HUNTINGDONSHIRE DISTRICT COUNCIL

Title/Subject Matter: Consultation by National Air Traffic Service-
Luton Airport flight path changes

Meeting/Date: Cabinet – 21st January 2021

Luton Airport Consultation- map of affected areas

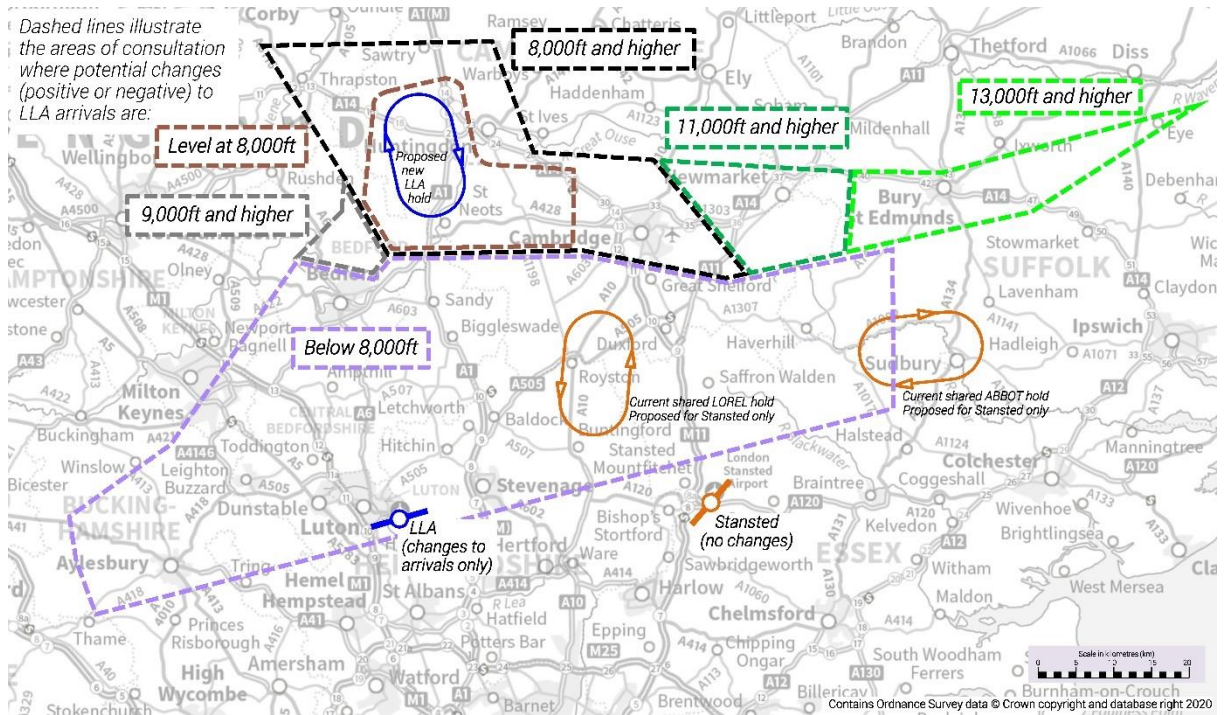
- 2.4 The main proposals relate to a re-routing of inbound flights as a result of the separation of the Luton and Stansted traffic and the associated creation of new dedicated airspace. The new airspace is to the south of Huntingdonshire, with aircraft starting their final descent to the south of St Neots. As such, this element of the proposals does not have a significant local impact. However, the proposals envisage the creation of a new holding pattern, to be used in the event of unscheduled congestion resulting in a "back-up" of approaching air traffic. This proposed holding zone would be in a loop pattern around the line of the A1 road, broadly from St Neots to Alconbury. A map showing a summary of these proposals, extracted from the NATS documents, is attached as Appendix 1 to this report.

- 1) The Panel wants to place on record its dissatisfaction that data has not been provided to demonstrate the impact of the holding area in alternative location options against the published criteria. It is assumed that for the methodology to be sound, alternatives will have been appraised, including the “do nothing” option. The data for these should be published and consulted on. For these reasons, the Panel recommend that the proposals be not implemented.

- 2) The Panel expressed disappointment that there had not been more transparency around the need for the proposals, with little consideration of alternative options, for positioning of the proposed holding zone and asked that NATS supply more information on this.

- 5) The Panel asked whether, if the holding zone remains positioned as proposed, that the Cabinet can state in the consultation response whether it would be possible to raise the minimum flying height within the holding zone to 9000ft to reduce the potential for noise from planes within the holding zone to cause nuisance at ground level. The reasoning for this is the documentation states that noise from a plane at 8000ft would be approximately 55db and the ambient background noise within parts of the countryside would be 29db, therefore meaning the noise from the plane could be intrusive upon residents living in rural areas of the District.

- 9) It was clear to the Panel that the military was not fully consulted on the proposals and Members would like Cabinet to ask NATS if they could consult with the military on whether they require all of the air space allocated to them and if the holding zone could not be located over a more rural area of the county but within current military airspace.
